Project	<b>IEEE 802.16 Broadband Wireless Access Working Group</b> < <a href="http://ieee802.org/16">http://ieee802.org/16</a> >	
Title	<b>Location Measurement Enhancements for meeting E911 Phase II Accuracy Requirements</b>	
Date Submitted	<b>2006-11-10</b>	
Source(s)	Joey Chou	<a href="mailto:joey.chou@intel.com">[mailto:joey.chou@intel.com]</a>
	Stuart Golden	<a href="mailto:stuart.golden@intel.com">[mailto:stuart.golden@intel.com]</a>
	Intel Corporation	
Re:		
Abstract	This contribution proposes location measurement enhancements that are necessary to meet E911 Phase II requirements, and the needs for other Location Based Services (LBS).	
Purpose	Adoption	
Notice	This document has been prepared to assist IEEE 802.16. It is offered as a basis for discussion and is not binding on the contributing individual(s) or organization(s). The material in this document is subject to change in form and content after further study. The contributor(s) reserve(s) the right to add, amend or withdraw material contained herein.

3 This contribution proposes location measurement enhancements that are necessary to meet E911  
4 Phase II requirements, and the needs for other Location Based Services (

22 **Figure G2—U-TDOA Measurement Timing Diagram (FRF > 1)**

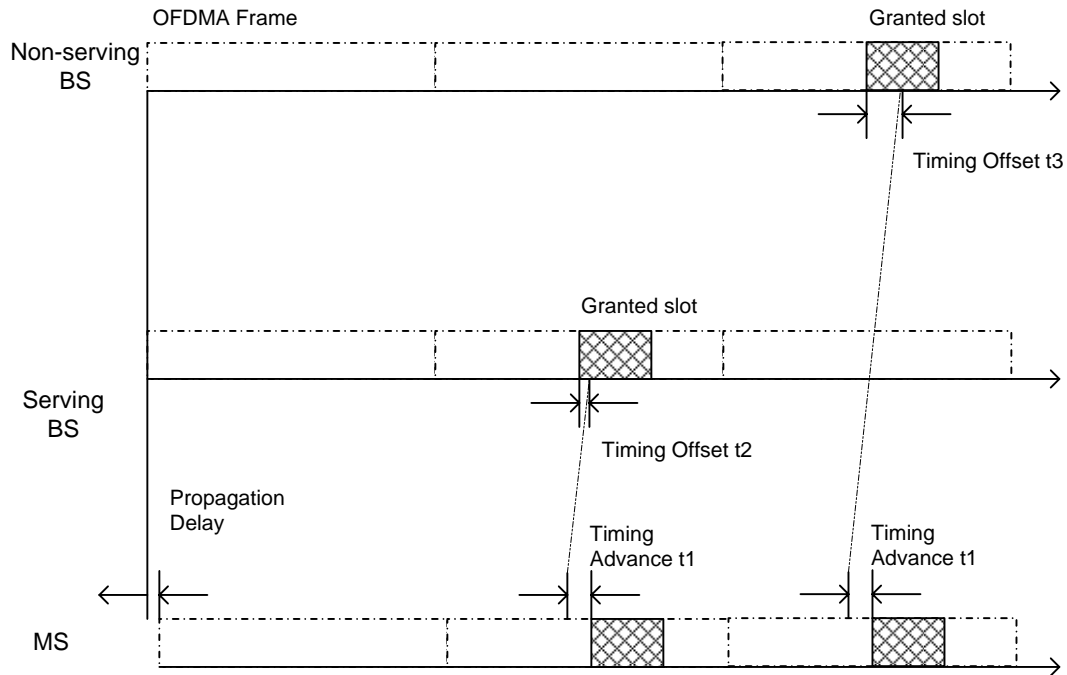
15 Figure G2 does not take into account the one way propagation delay from BS to MS.

17 [\[Change Figure G2 and Figure title with the following diagram:\]](#)

24 [\[Change the paragraphs after Figure G2 as the following:\]](#)

26 The propagation delay for serving BS and non-serving BS 1 can be derived from the  
 27 equation below, assuming the frames of serving BS and non serving BS are  
 28 synchronized. The sum of timing adjustment and timing advance equals to two times of  
 29 MS to BS propagation delay. The propagation delay for non-serving BS II can be  
 30 obtained from the same approach.

37 **Figure G3—U-TDOA Measurement Algorithm (FRF > 1)**

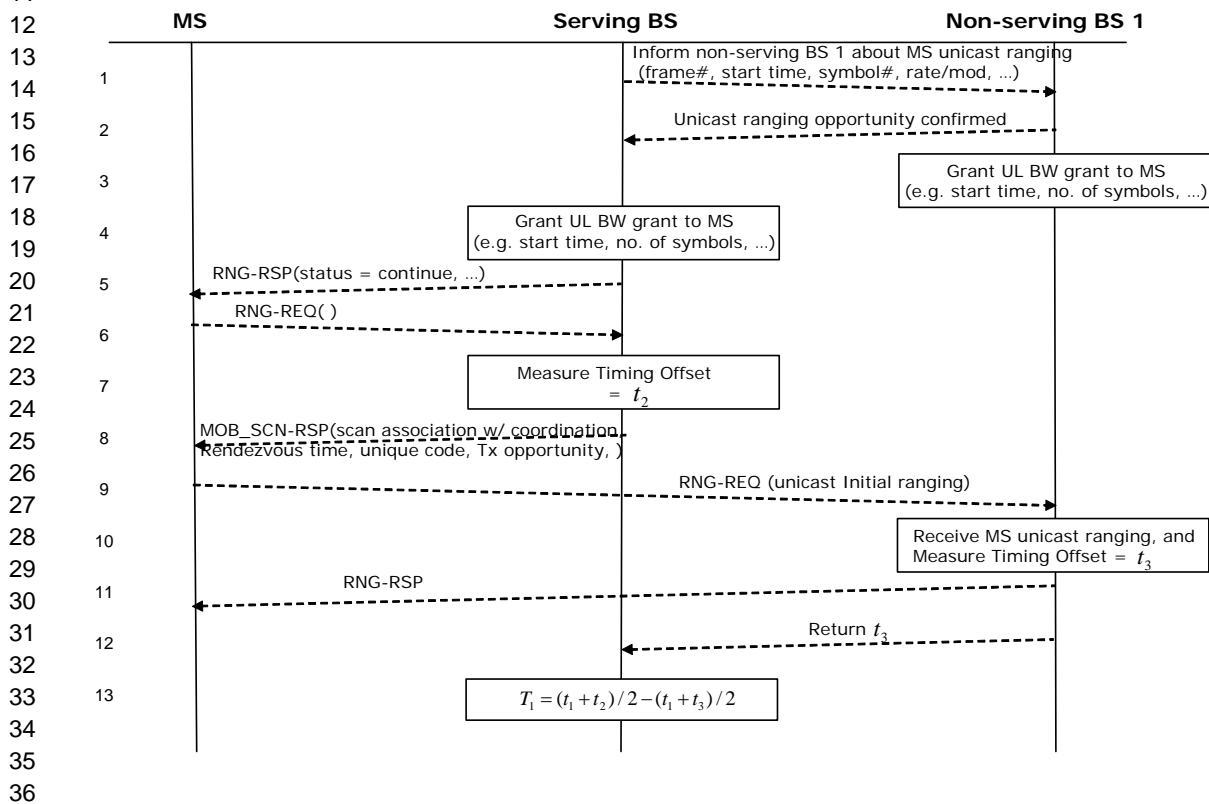
7  
8  
9 [Change Figure G3 and Figure title with the following diagram:]

38  
39 [Change the algorithm as the following:]

- 40  
41 1. Serving BS informs non-serving BS 1 about MS is going to do unicast ranging by  
42 passing frame number, start time, number of symbols, ...
- 43 2. Non-servicing BS 1 confirms unicast ranging opportunity for MS
- 44 3. Non-serving BS 1 grant such UL slot to the MS
- 45 4. Serving BS allocates a UL slot for MS to do unicast ranging.

- 1 5. Serving BS sends an autonomous RNG-RSP message (Ranging Status = Continue)
- 2 to ask MS performing unicast ranging
- 3 6. When MS receives the RNG-RSP from serving BS, it shall send RNG-REQ at the
- 4 assigned slot
- 5 7. Serving BS 1 measures Timing Offset  $t_2$
- 6 8. Serving BS sends autonomous MOB\_SCN-RSP with scanning type = 0b10 (scan
- 7 association with coordination) to force MS performing initial ranging after scan
- 8 9. MS synchronizes with non-serving BS 1, and sends RNG-REQ
- 9 10. Non-serving BS 1 receives unicast ranging, and measures Timing Adjustment  $t_3$
- 10 11. Non-serving BS returns RNG-RSP with Timing Adjustment =  $t_1 + t_2$  to MS
- 11 12. Non-serving BS returns Timing Offset  $t_3$  to serving BS
- 12 13. Serving BS reads the Timing Advance  $t_1$  that was captured previously, and calculates U-
- 13 TDOA  $T_1 = (t_1 + t_2)/2 - (t_1 + t_3)/2$

**Figure G4—U-TDOA Measurement Timing Diagram (FRF = 1)**

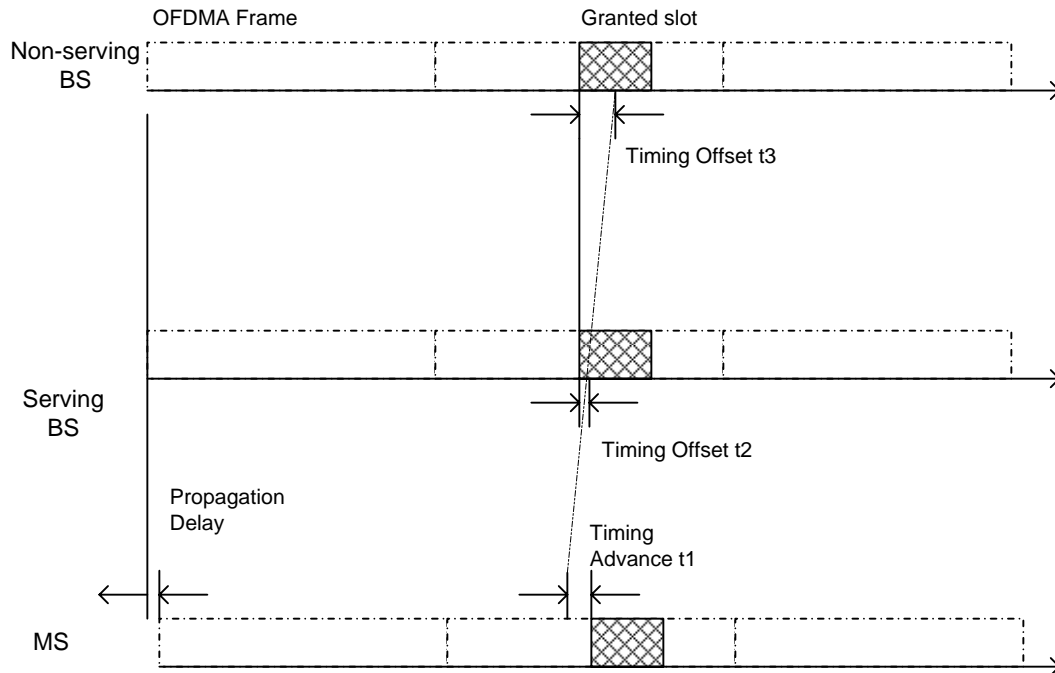
Figure G4 does not take into account the one way propagation delay from BS to MS.

[Change Figure G4 and Figure title with the following diagram:]

[Change the paragraphs after Figure G4 as the following:]

The propagation delay for serving BS and non-serving BS 1 can be derived from the equation below, assuming the frames of serving BS and non serving BS are synchronized. The sum of timing adjustment and timing advance equals to two times of MS to BS propagation delay. The propagation delay for non-serving BS II can be obtained from the same approach.

Figure G5—U-TDOA Measurement Algorithm (FRF = 1)

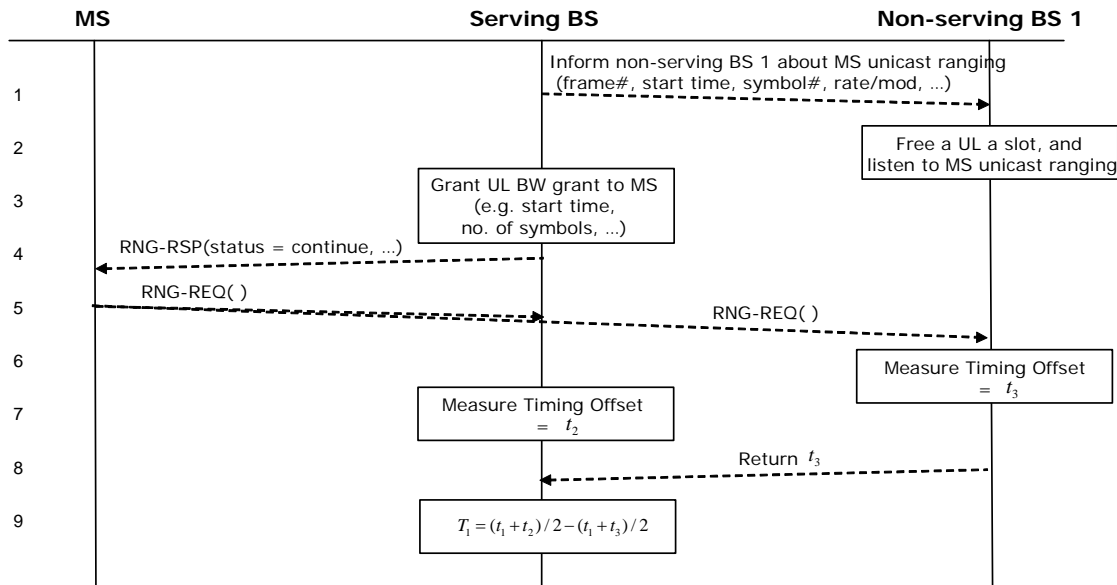
[Change Figure G5 and Figure title with the following diagram:]

[Change the algorithm as the following:]

1. Serving BS informs non-serving BS 1 about MS is going to do unicast ranging by passing frame number, start time, number of symbols, ...

- 1     2. Non-serving BS 1 does not grant such UL slot to any MS, and listens to the unicast  
2        ranging from MS
- 3     3. Serving BS allocates a UL slot for MS to do unicast ranging.
- 4     4. Serving BS sends an autonomous RNG-RSP message (Ranging Status = Continue)  
5        to ask MS performing unicast ranging
- 6     5. When MS receives the RNG-RSP from serving BS, it shall send RNG-REQ at the  
7        assigned slot that can be received by non-serving BS.
- 8     6. Non-serving BS 1 measures Timing Offset  $t_3$
- 9     7. Serving BS measures Timing Offset  $t_2$
- 10    8. Non-serving BS 1 returns Timing Offset  $t_3$  to serving BS
- 11    9. Serving BS reads the Timing Advance  $t_1$  that was captured previously, and calculates U-  
12        TDOA  $T_1 = (t_1 + t_2)/2 - (t_1 + t_3)/2$
